# VALUE ENGINEERING REPORT

Projects No. STP00-0002-00(409) and NH000-0006-02(056)

SR 300/SR 520 / US 82 Clark Avenue between Turner Field Road and  
SR 62 Cordele Road Improvements  
and  
SR 3 / Liberty Expressway @ Clark Avenue Ramps and Turn Lanes  
Improvements

November 16, 2010

<b>IDEA No.:</b>	<b>PAGE No.:</b>	<b>CREATIVE IDEA:</b>
A-1	1 of 4	Re-use existing pavement
Comp By: GAO		Date: 11/3/10
		Checked By: DCW
		Date: 11/3/10

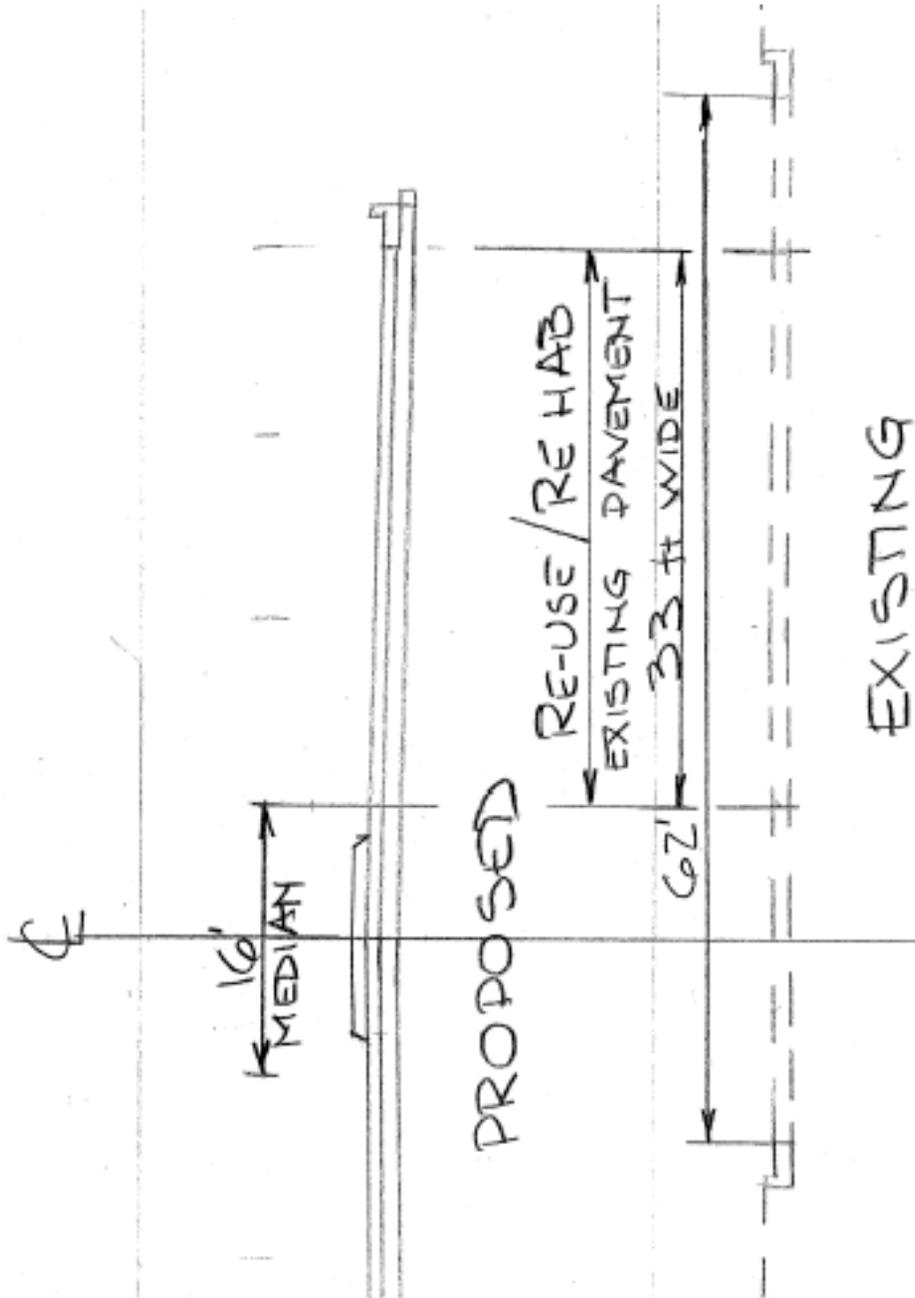
Totally remove and reconstruct full depth pavement for the entire project. The proposed pavement is 10.5 inches of asphalt over 12 inches of graded aggregate base.

Rather than full depth pavement reconstruction, rehabilitate and resurface the existing pavement, where feasible. Based on the roadway widening and the non-symmetrical alignment, this will only apply to the 33 foot wide, EB lanes. This idea was based on the concept of re-using the existing pavement, which was recommended by the District during the kickoff presentation.

The draft pavement evaluation calls for total pavement removal and full depth reconstruction throughout the project. If, however, the final report allows for rehabilitation and resurfacing, there could potentially be some savings, although only a 33-foot wide area for the EB lanes would be suitable for re-use. Most of the widening is to the north, where only a narrow, 3 - 5 foot section of roadway will remain. This width is not sufficient for re-use.

Assume re-use and re-habilitation of 33 feet of existing roadway, using a 3.5 inch overlay in lieu of full depth reconstruction. The cost saving would allow for up to 3 future resurfacings.

<b>IDEA No.:</b>	<b>PAGE No.:</b>	<b>CREATIVE IDEA:</b>	
A-2	1 of 4	Remove full-depth pavement under median	
Comp By: SWG		Date: 11/4/10	Checked By: DCW
		Date: 11/4/10

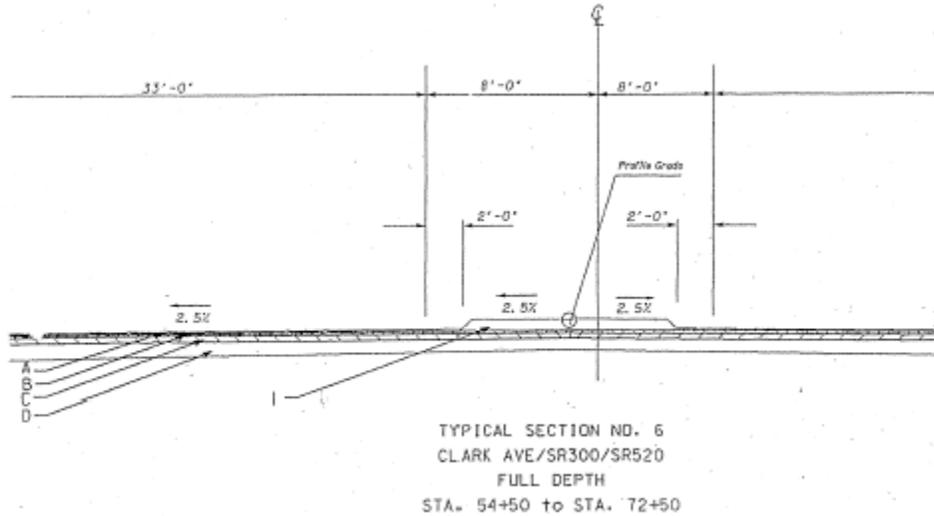
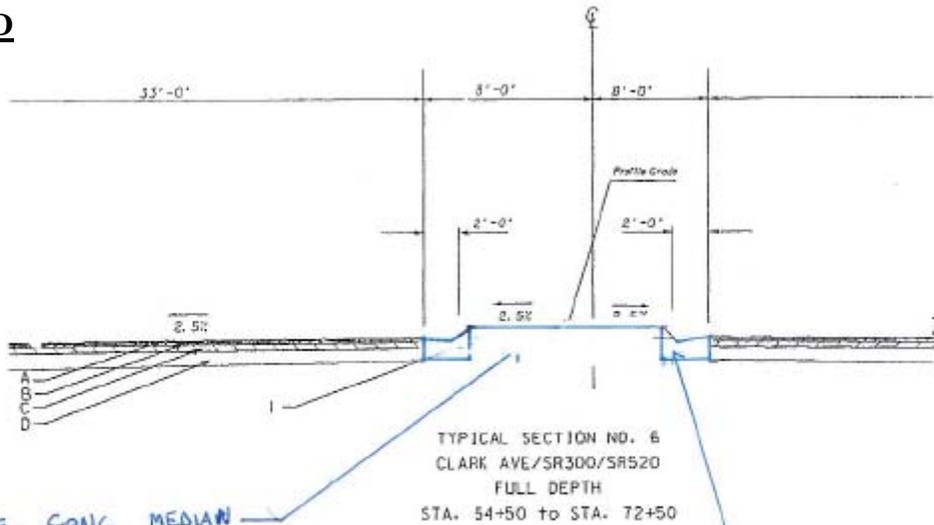
The original concept proposes to install full-depth pavement under the raised concrete median.

The revised concept proposes to install a raised grass median with Type 7 curb & gutter. No pavement will be installed in the median.

The function of the median is to separate traffic. This function can be accomplished without the installation of full-depth pavement under the median.

REMOVE CONC MEDIATE  
 PUNT AND FULL DEPTH  
 ASPHALT PUNT

INSTALL TYPE 7  
 CURB+ GUTTER

<b>IDEA No.:</b> A-2.1	<b>PAGE No.:</b> 1 of 5	<b>CREATIVE IDEA:</b> Reduce full-depth pavement thickness under median
---------------------------	----------------------------	--

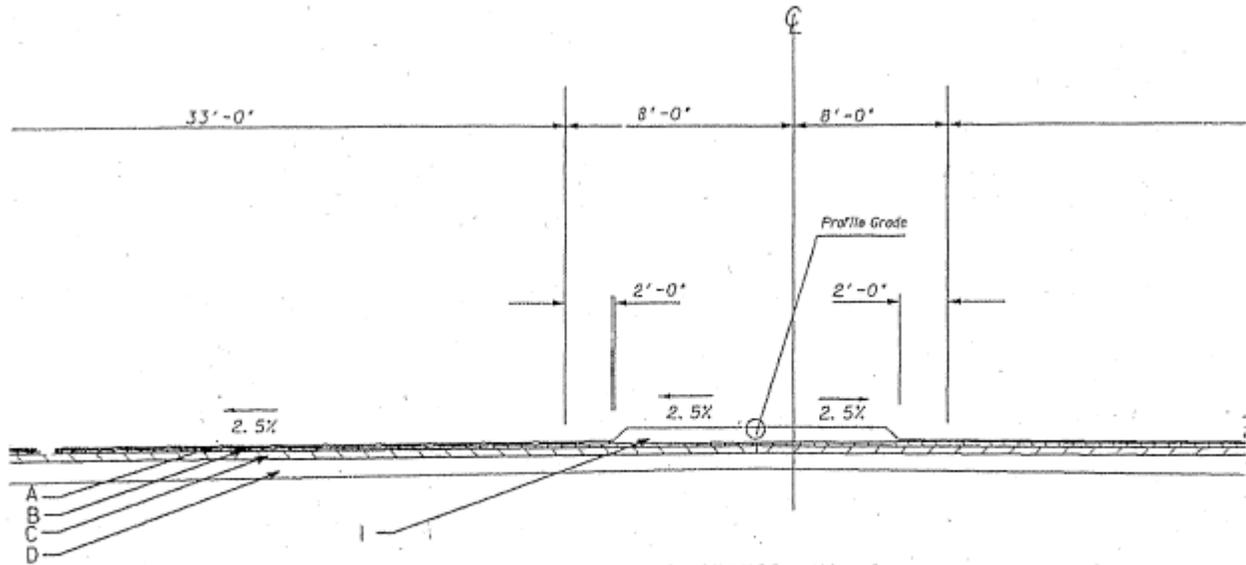
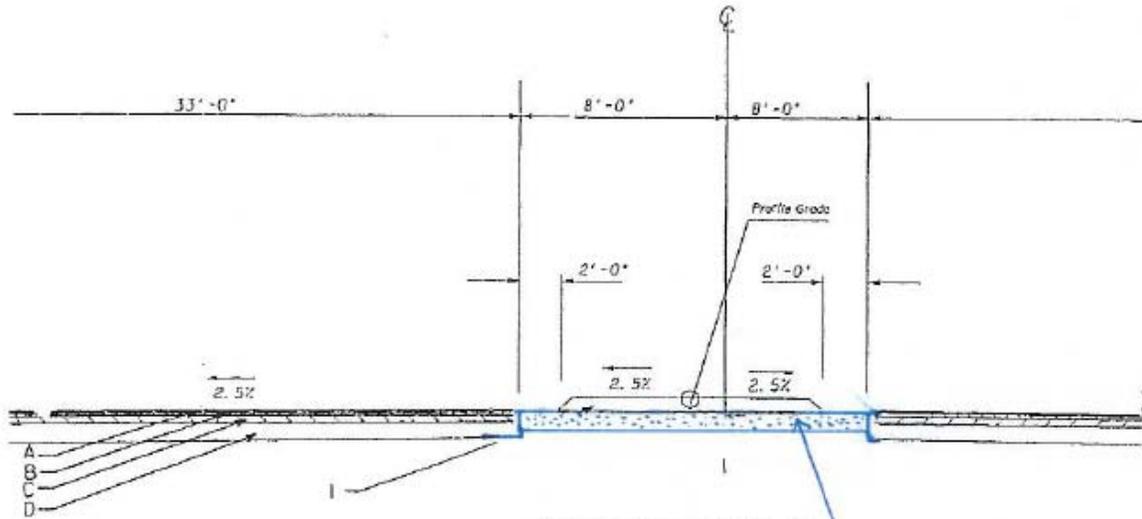
The original concept proposes to install full-depth pavement under the raised concrete median. This pavement section is 1.5" of 12.5mm, 2" of 19mm, 7" of 25mm & 12" GAB.

The revised concept proposes to install a reduced-depth pavement section under the median. This pavement section is 1.5" of 12.5mm, 2" of 19mm, 3" of 25mm & 8" GAB.

The function of the pavement under the median is to facilitate maintenance of traffic (staging) during construction and to support the median. The pavement section for temporary pavement will be adequate to serve this function and will result in significant cost savings.

INSTALL TEMPORARY  
PAVEMENT SECTION  
UNDER MEDIAN

ITEM N<sup>o</sup>: A-4  
CLIENT: GDOT  
Sheet 2 of 5

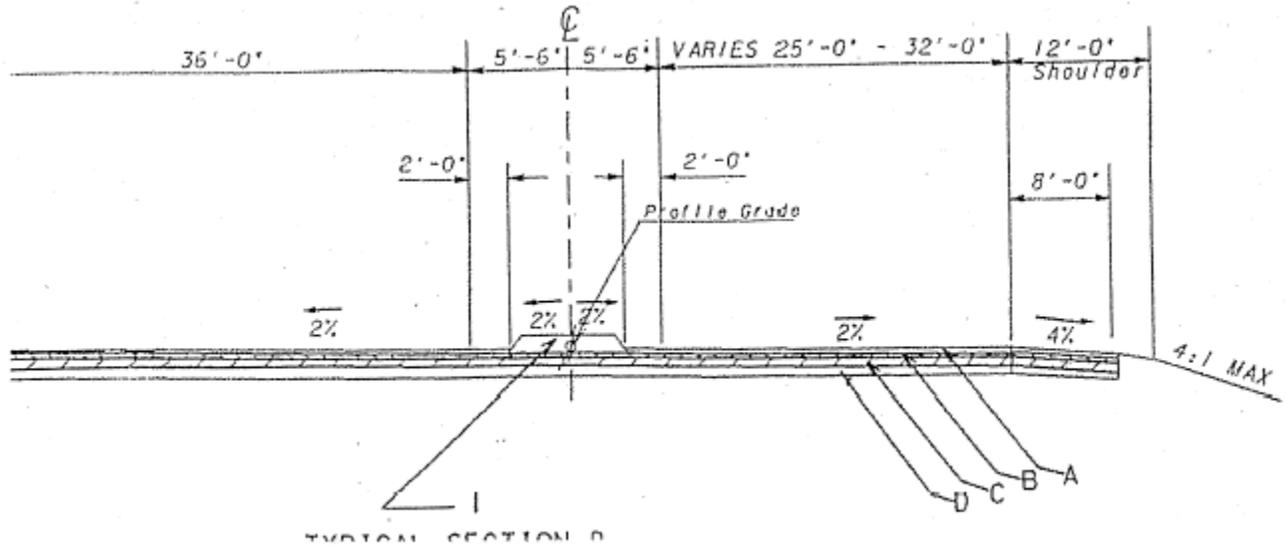
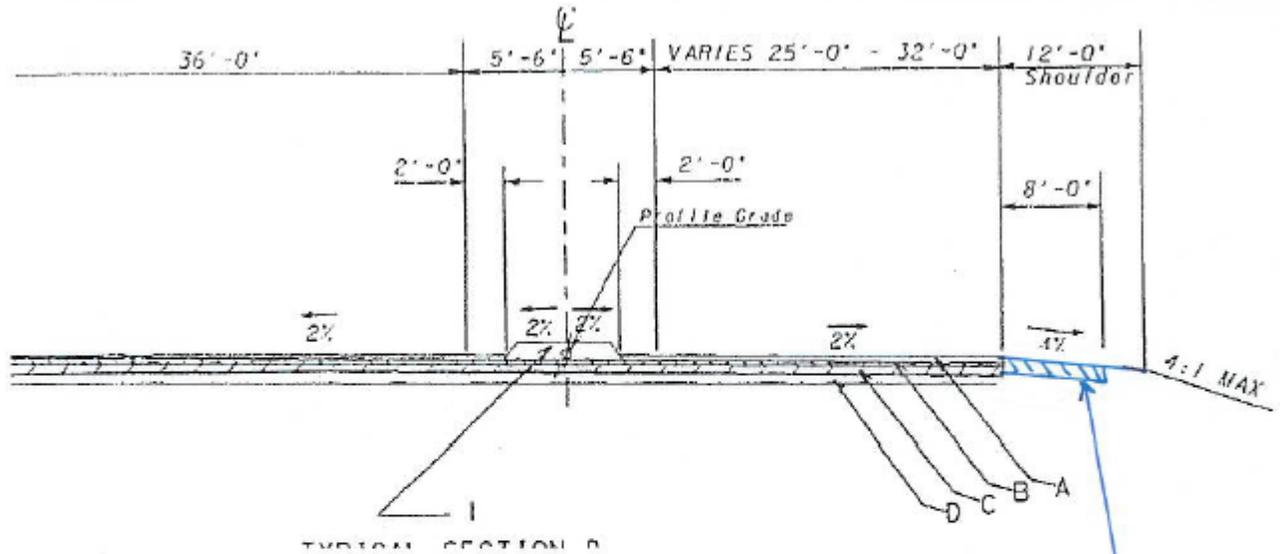
The revised concept proposes to install a reduced pavement section on the ramp shoulders. This pavement section is 1.5" of 12.5mm, 2" of 19mm, and 6" GAB.

The function of the ramp shoulders is to support the occasional vehicle that pulls off the ramp, and not to support mainline traffic. A reduced pavement section will adequately serve this function and create significant cost savings.

REDUCE PAVEMENT DEPTH  
FOR RAMP SHOULDERS

ITEM N<sup>o</sup>: A-7  
CLIENT: GDOT  
Sheet 2 of 5

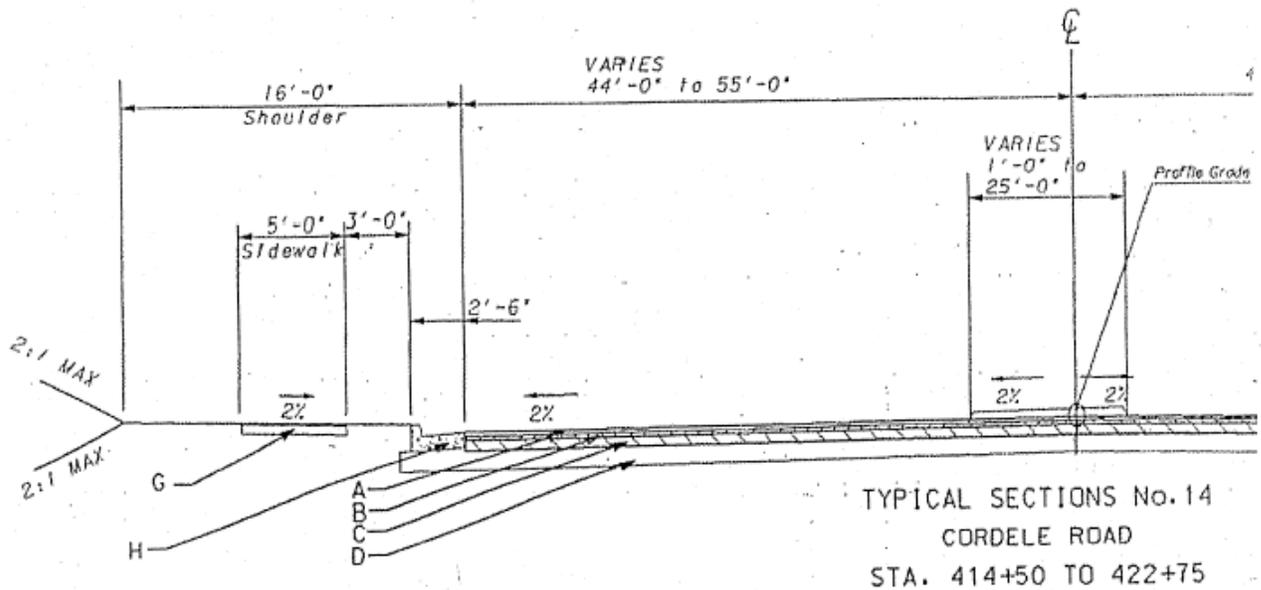
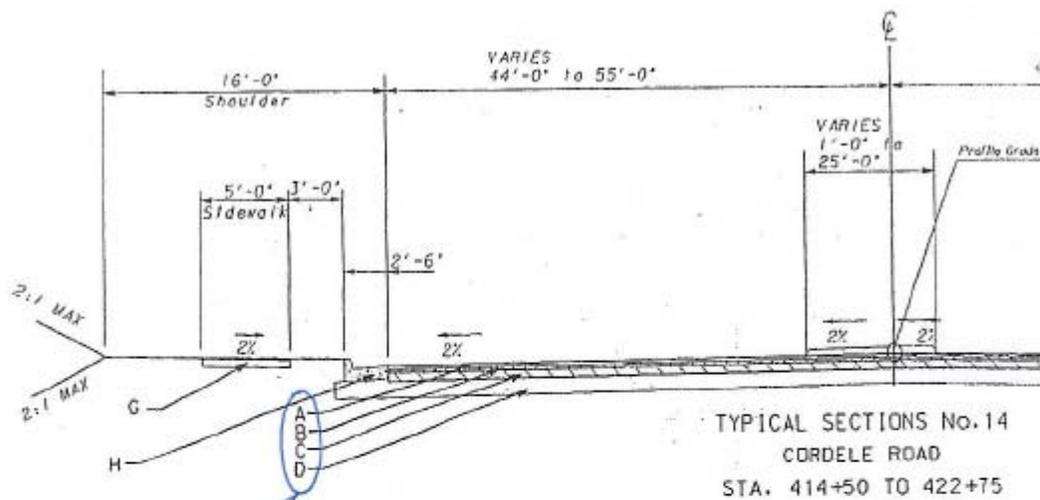
The revised concept proposes to install a reduced pavement section for Cordele Road. This pavement section is 1.5" of 12.5mm, 2" of 19mm, 3" of 25mm, and 10" GAB.

The traffic volumes on Cordele Road are significantly lower than those on Clark Avenue. A reduced pavement section for Cordele Road will support projected traffic.

REDUCE PVMT DEPTH FOR CORDELE ROAD

ITEM N<sup>o</sup>: A-7.1  
CLIENT: GDOT  
Sheet 2 of 5

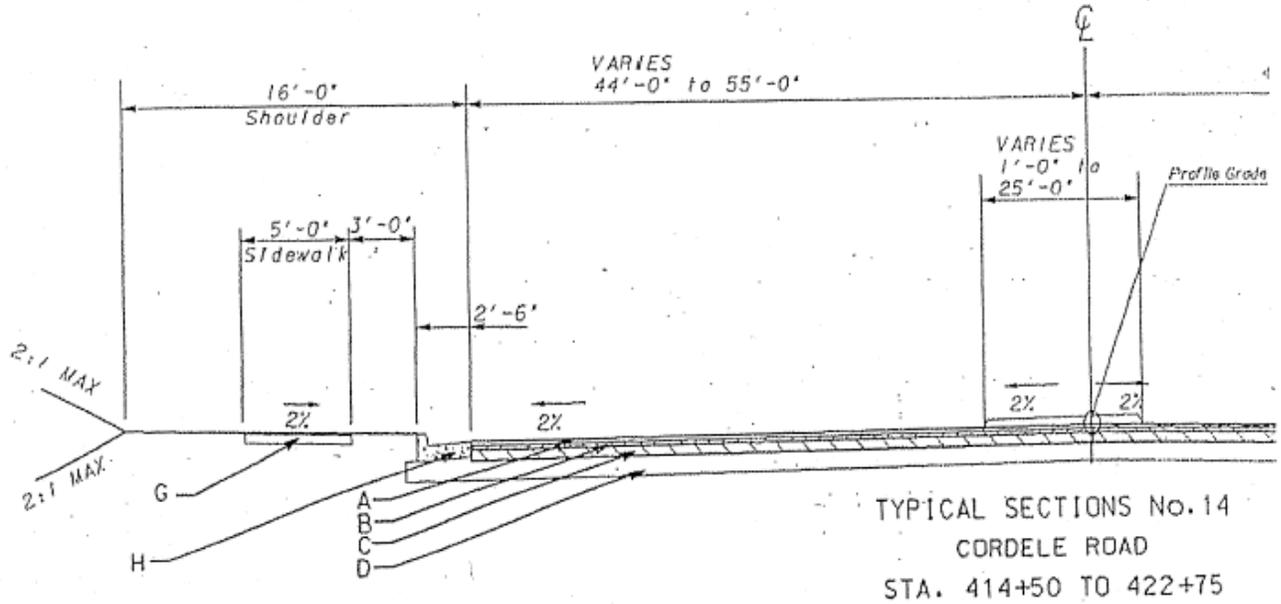
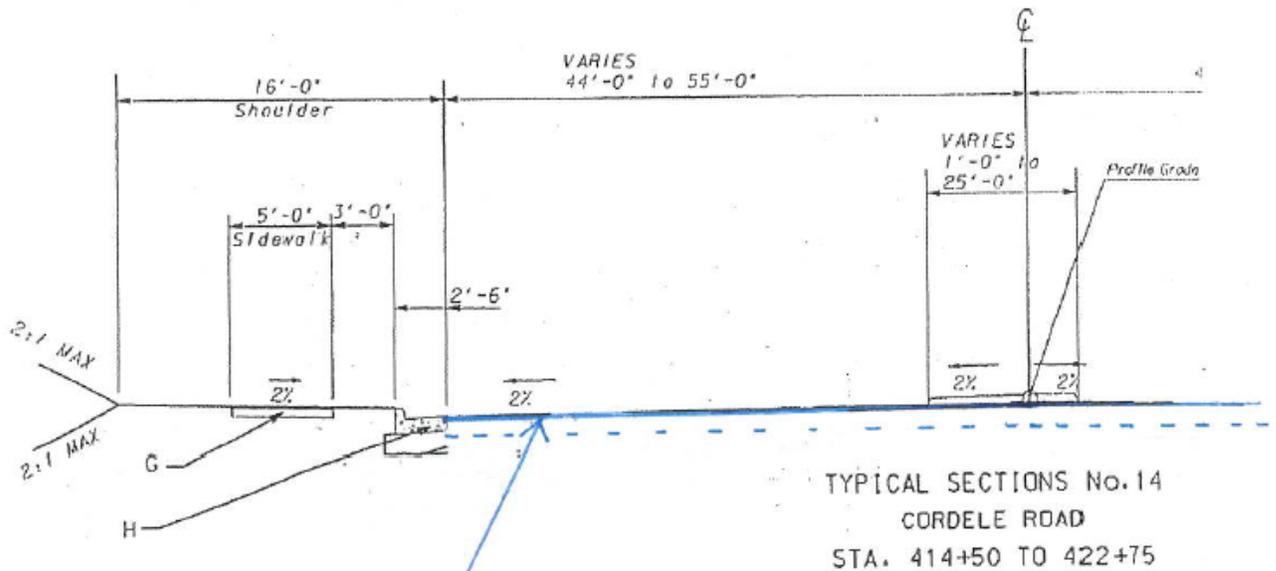
The revised concept proposes to implement 1.5" milling and 1.5" overlay (12.5mm) for Cordele Road.

The 2009 pavement evaluation report recommends 1.5" milling and 1.5" overlay (12.5mm) for Cordele Road.

IMPLEMENT MILLING AND  
OVERLAY INSTEAD OF  
FULL DEPTH PAVT

ITEM N<sup>o</sup>: B-4  
CLIENT: GDOT  
Sheet 3 of 5

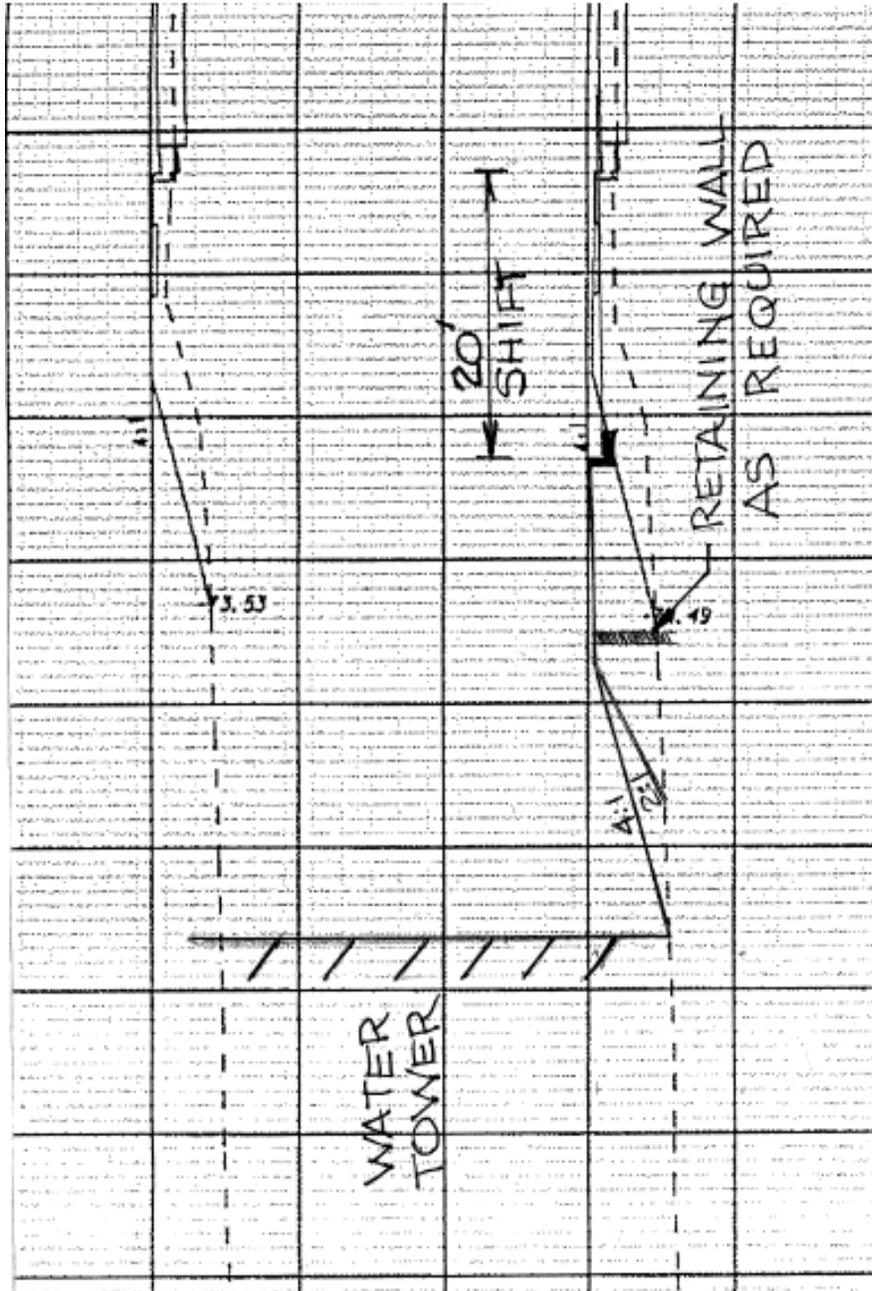
Maintain the tangent alignment through the area of the water tower.

The existing SR 300/ Clark Avenue alignment through this area is on a tangent. A horizontal alignment shift of about 20 feet to the south was developed to minimize impacts to the existing water tower located in the central portion of this project. This alignment shift introduces construction staging difficulties that will require temporary pavement construction. If the tangent alignment is maintained throughout the project, the construction staging scheme will be consistent (requiring no traffic shift) and the temporary pavement construction will be eliminated. Even with a 4:1 sideslope, there should be no adverse effects to the water tower. However, the limit of grading will be close to the base of the tower. Any adverse effects can be reasonably mitigated with steeper side slopes (2:1), a low (3-4 foot) retaining wall, and/or a minor realignment in the access driveway.
